Access Compliance Report

Public Rights-of-Way

Intersection ID: 44264	Main Street: ISAAC_HUNTER_DR	Cross Street: LAWING_SCHOOL_RD	Location: S
ADA ID: 0EB7DF3140A9	Ramp Type: Perp	Initial Pass/Fail: Fail	Overall Compliance: No
Codes/Mitigation Info/Possible Solution		Field Measurements/Component Compliance	
Severity Score: 33.75

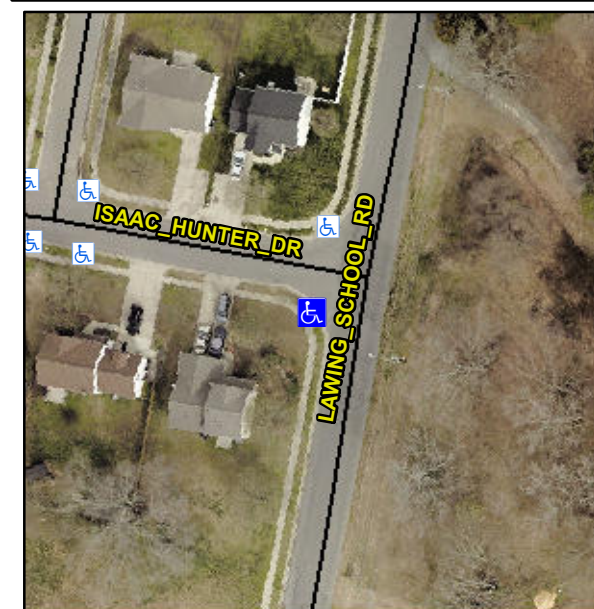
Not Found, R304.5.1, R304.2.2

Compliance	Description	Data	Compliance	Description	Data
N/A	Ramp Length (in)	47.0	No	Ramp Slope (%)	13.0
No	Ramp Width (in)	41.0	Yes	Ramp XSlope (%)	1.7
N/A	Flare Type LT	N/A	N/A	Flare Type RT	N/A
N/A	Flare Slope LT (%)	N/A	N/A	Flare Slope RT (%)	N/A
N/A	Flare Traversable LT?	N/A	N/A	Flare Traversable RT?	N/A
N/A	Landing Length (in)	N/A	N/A	DWS Provided?	N/A
N/A	Landing Width (in)	N/A	N/A	DWS Contrast?	N/A
N/A	Landing Slope (%)	N/A	N/A	DWS Length (in)	N/A
N/A	Landing X Slope (%)	N/A	N/A	DWS Full Width?	N/A
N/A	Landing Curb? (Y/N)	N/A	N/A	DWS Offset (in)	N/A
N/A	Shared Landing?	N/A			
N/A	Gutter Ponding?	N/A	N/A	Gutter Slope (%)	N/A
N/A	Gutter Lip Ht (in)	N/A	N/A	Gutter X Slope (%)	N/A
N/A	Painted X Walk1?	No	N/A	Painted X Walk2?	N/A
	X Walk 1 Direction	To N		X Walk 2 Direction	N/A
N/A	X Walk 1 Width (in)	N/A	N/A	X Walk 2 Width (in)	N/A
	X Walk 1 Slope (%)	0.4		X Walk 2 Slope (%)	N/A
	X Walk 1 X Slope (%)	2.7		X Walk 2 X Slope (%)	N/A

Remove & Replace Entire Ramp.
